CITY OF BUELLTON
Planning Commission Agenda Staff Report

Subject: Resolution No. 22-13 – “A Resolution of the Planning Commission of the City of Buellton, California, Denying a Conditional Use Permit (21-CUP-02) and Sign Exemption (22-EXP-01) for a New Drive-Through Restaurant Located at 515 McMurray Road, Assessor’s Parcel Number 137-170-046, and Making Findings in Support Thereof”

Figure 29
Vehicle Turning Path Analysis

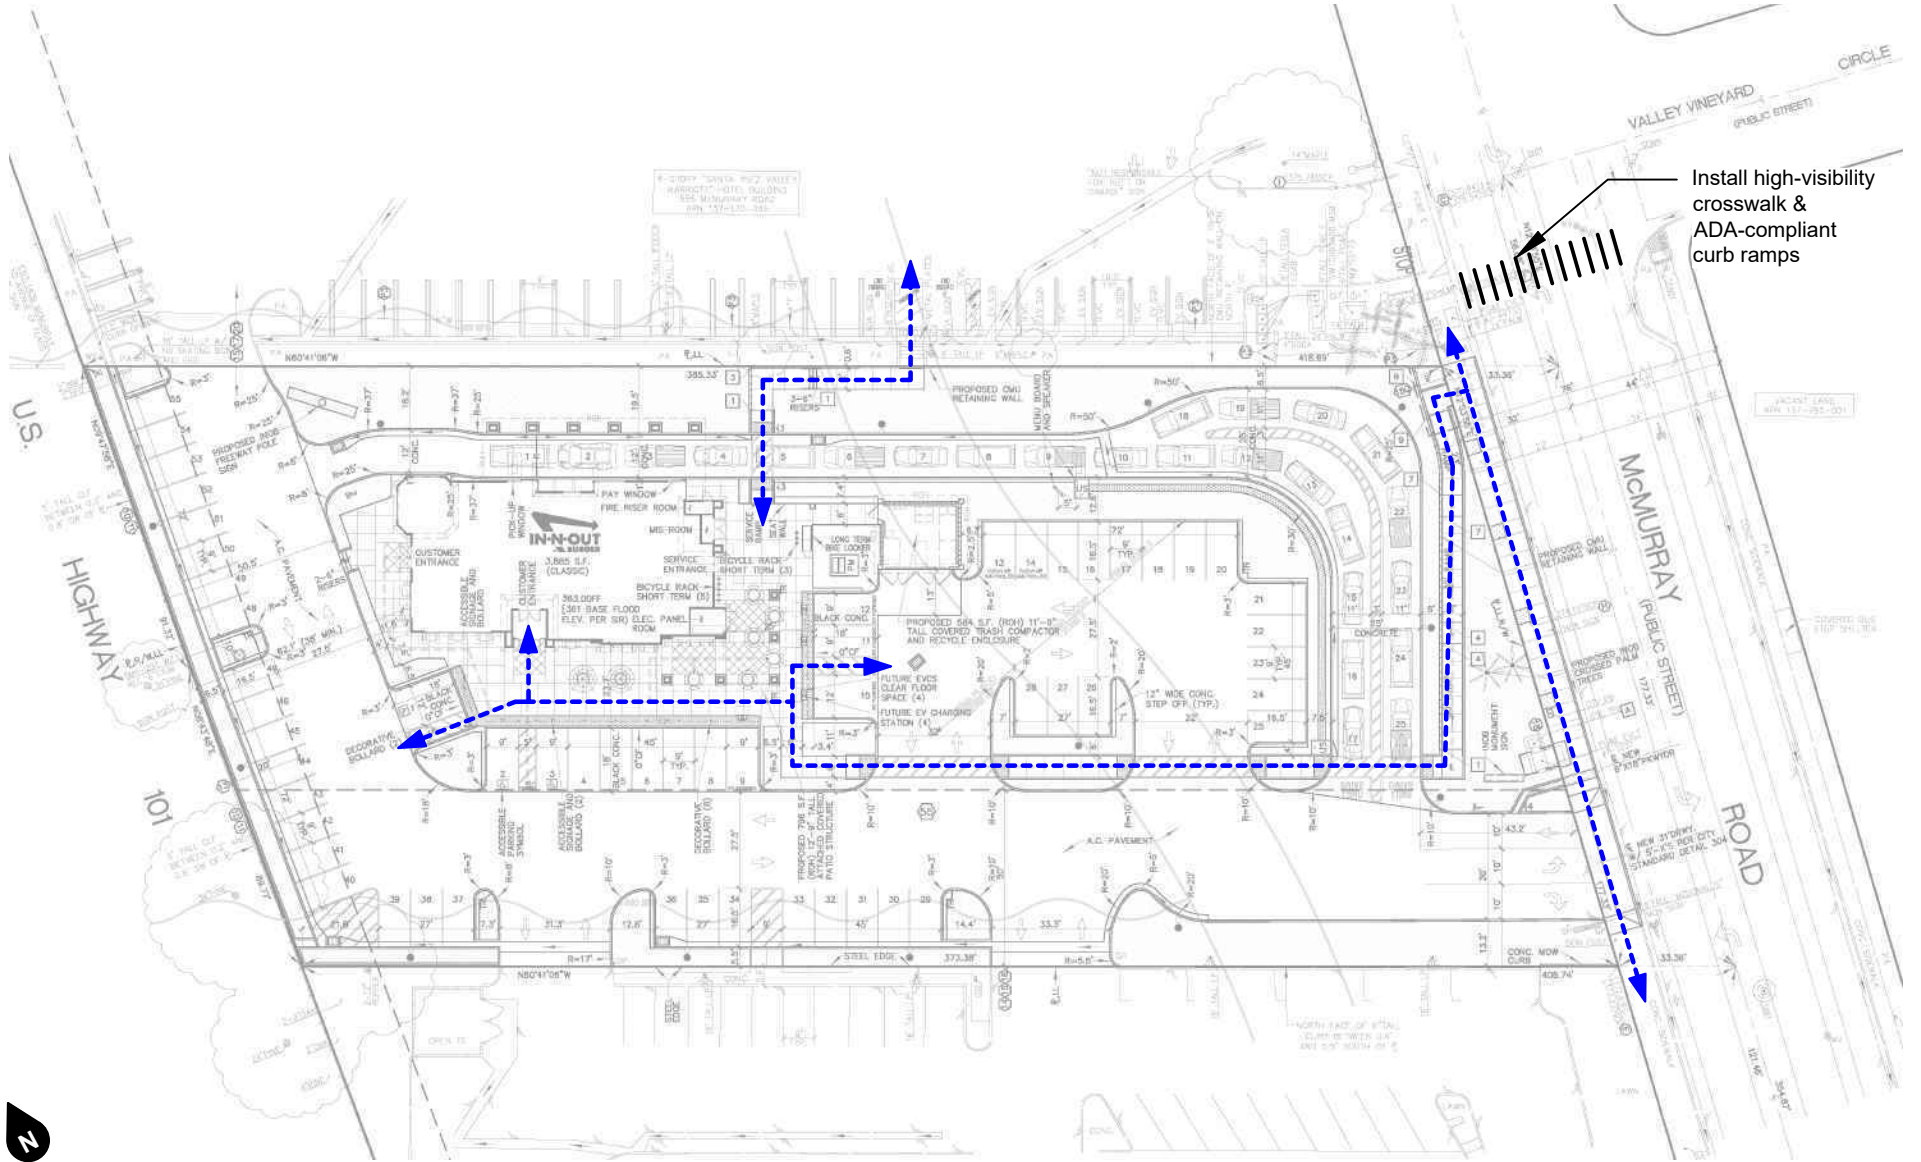
In addition to the turning paths shown in the report on Figure 29, ATE's Figure 1 illustrates the onsite traffic movements. Figures 2 through 5 show the movements from and to McMurray Road and vehicle entering the drive-thru lane, parking areas and McDonalds Restaurant. The driver entering the drive-thru lane must be cautious as the turn is sharp. Also, in the Buellton area, there are many vehicles larger than autos (crew-cab pickups and large SUV's).

VEHICLE TURNING PATH - SB RIGHT-TURN ENTERING TO DRIVE-THRU

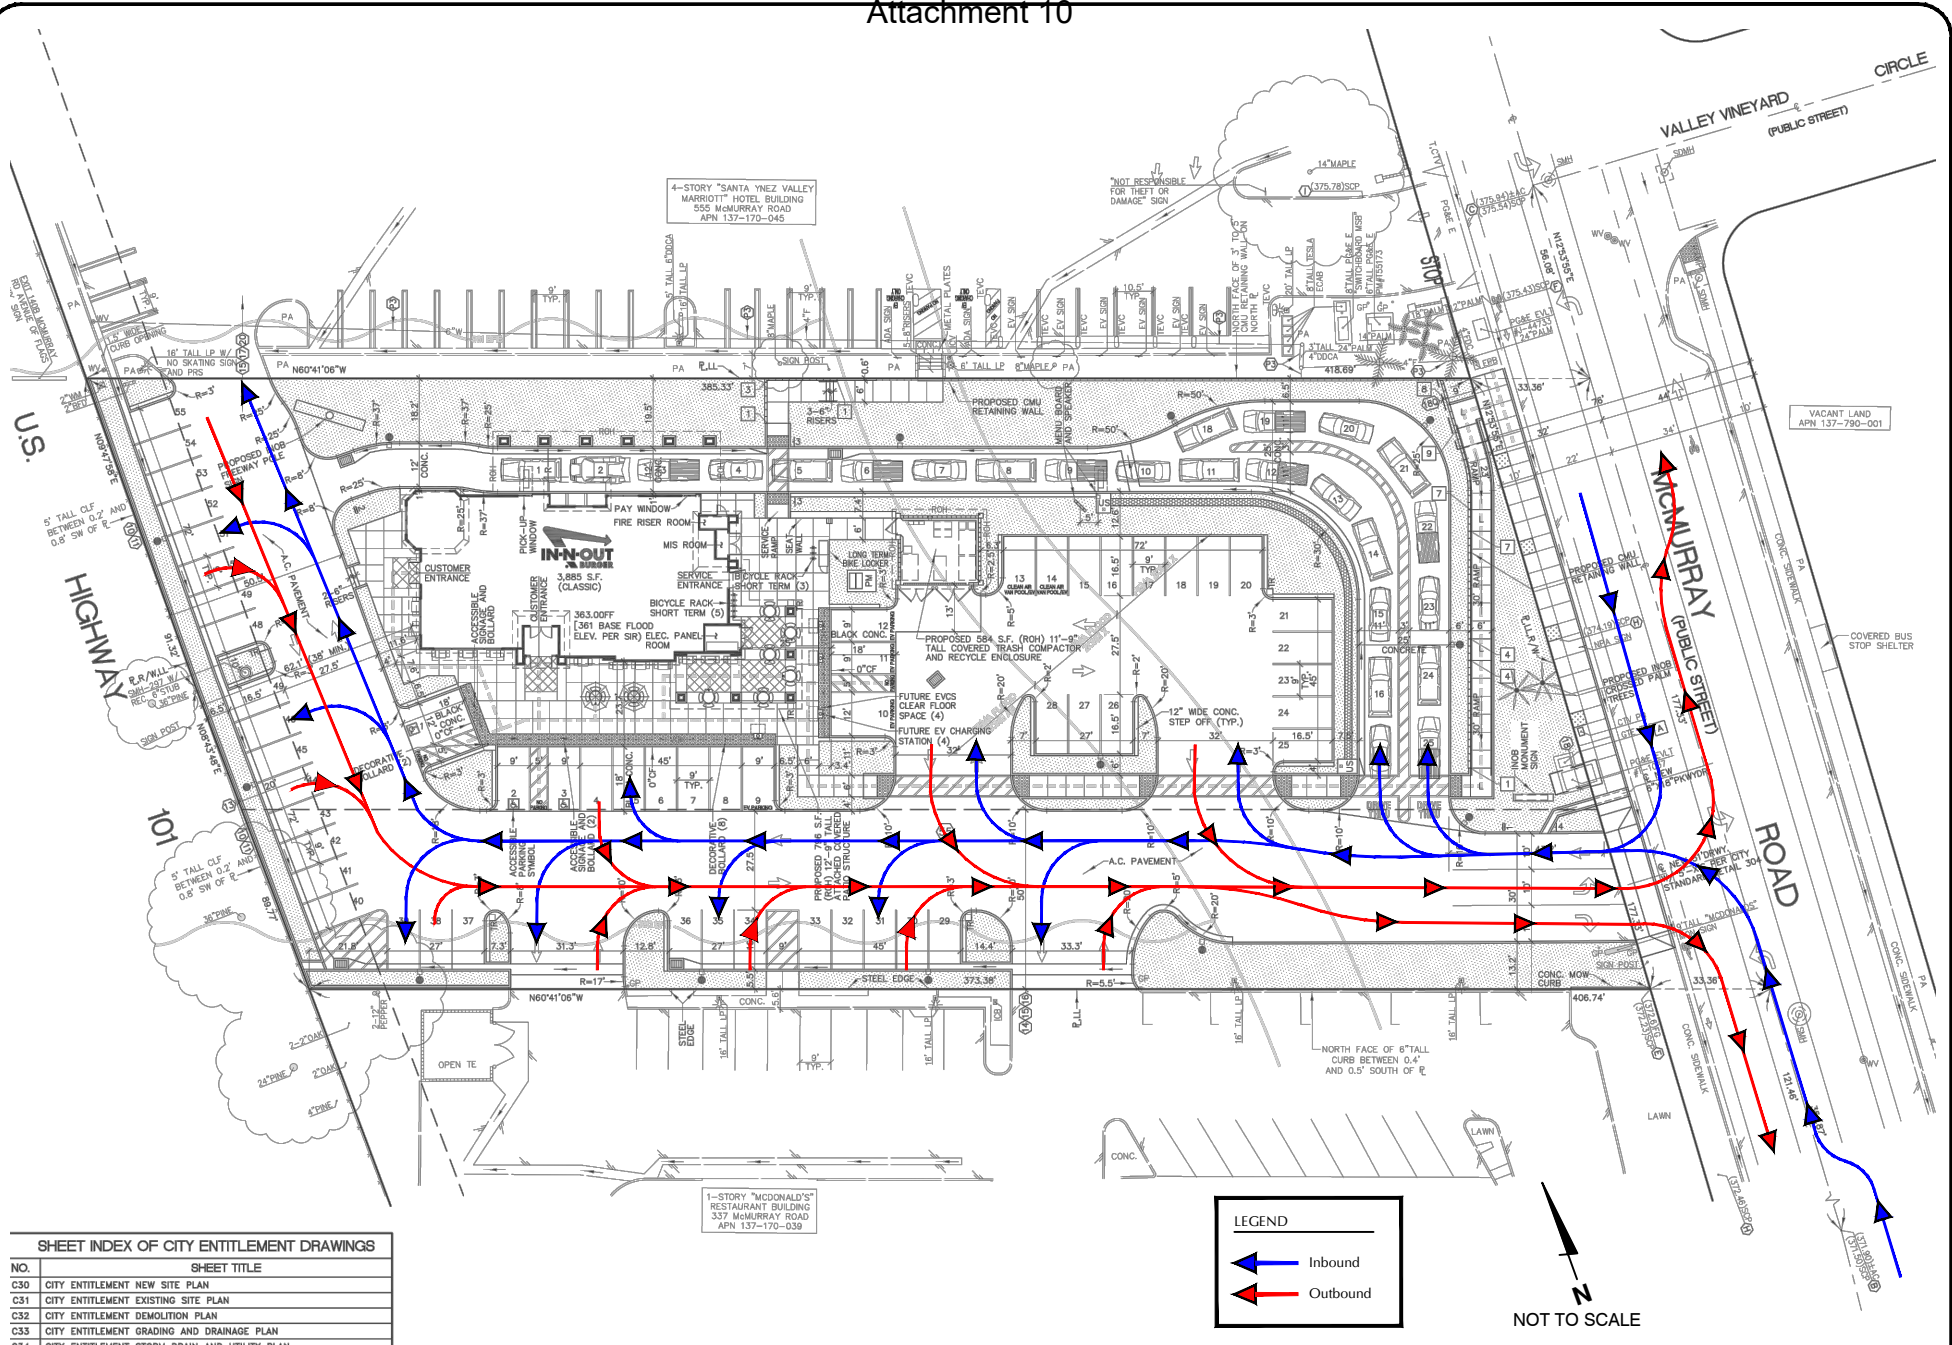
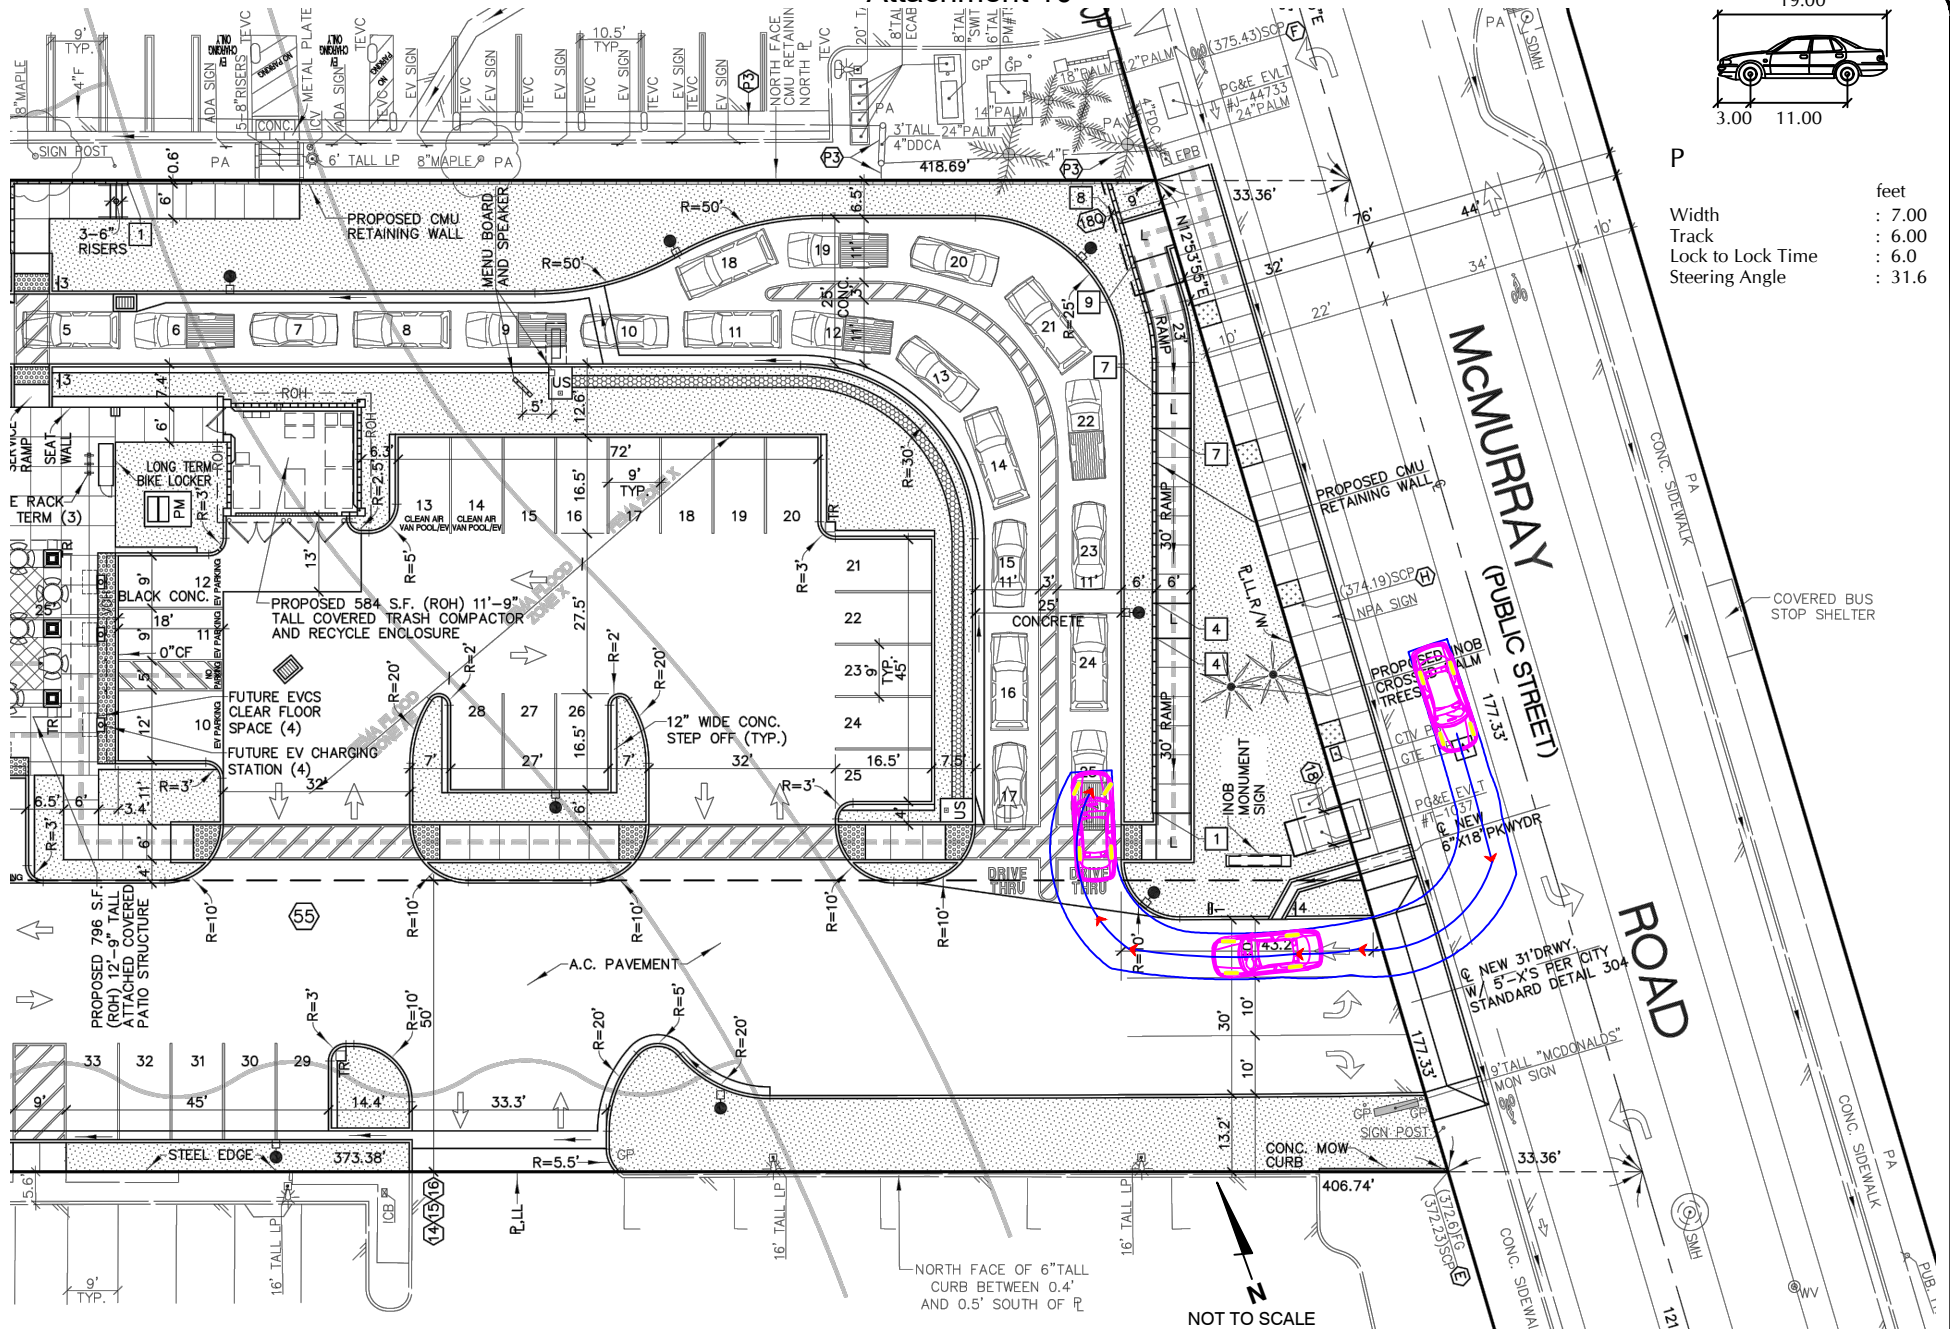
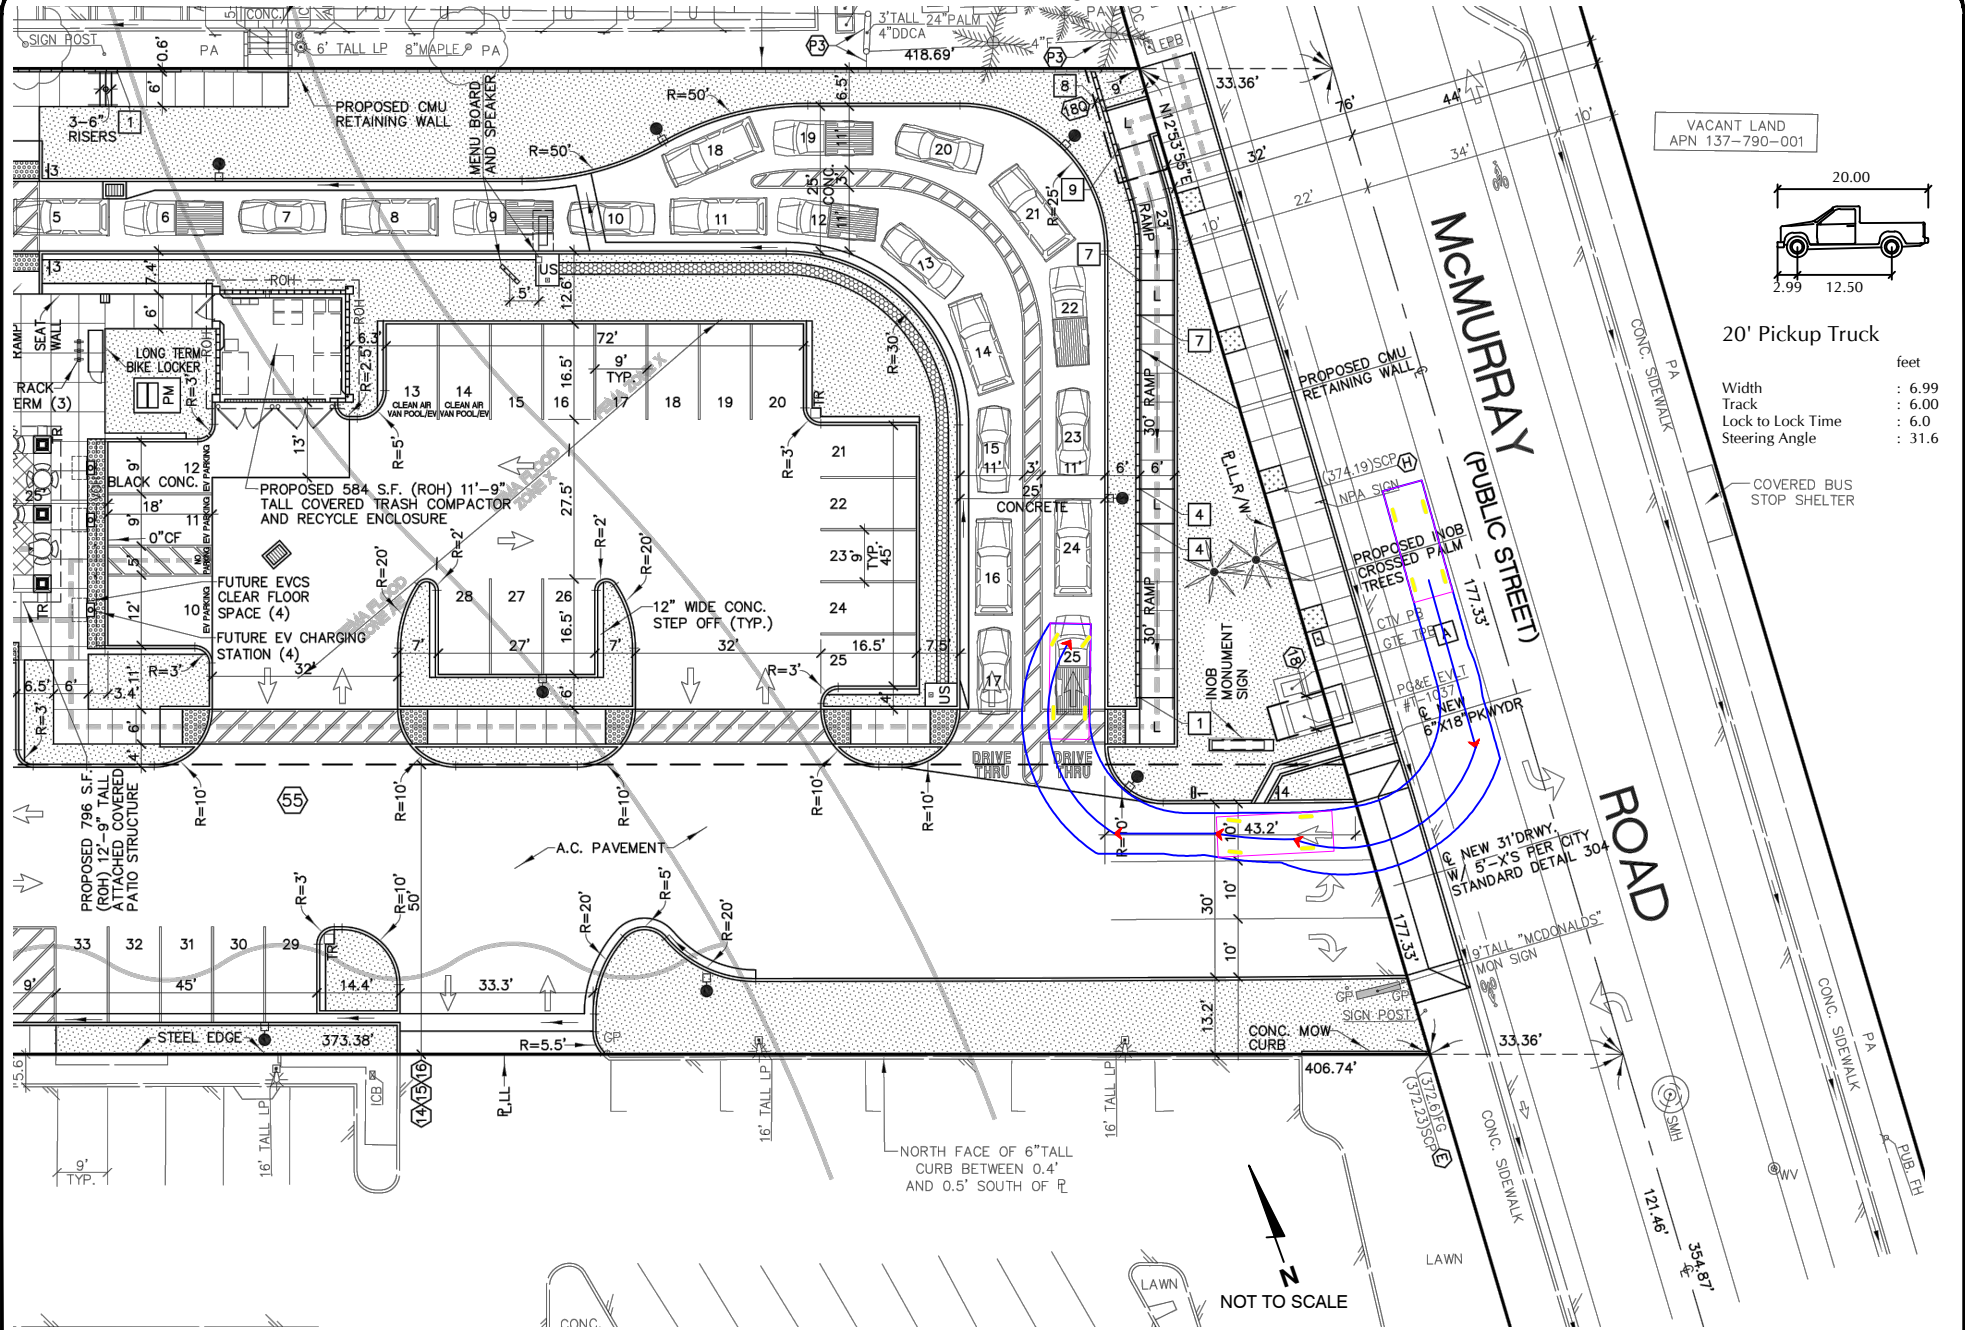
The calculation does not reflect the physical constraint at the driveway. There are 3 10-foot-wide lanes in the driveway, 1 inbound lane, and two outbound lanes. The entrance to the drive-thru lane is about 50 feet from the face of curb on McMurray Road. 50% of the project's inbound trips turn into the drive-thru lanes. The driveway weekday PM peak hour total inbound volume is 173 vehicles, the outbound volume is 116. The through volumes on McMurray Road are 157 southbound and 197 northbound (Figure 19 report). On Saturday Mid-day the peak hour volumes are 256 inbound and 197 outbound. The through volumes on McMurray Road are 157 southbound and 146 northbound (Figure 20 report).
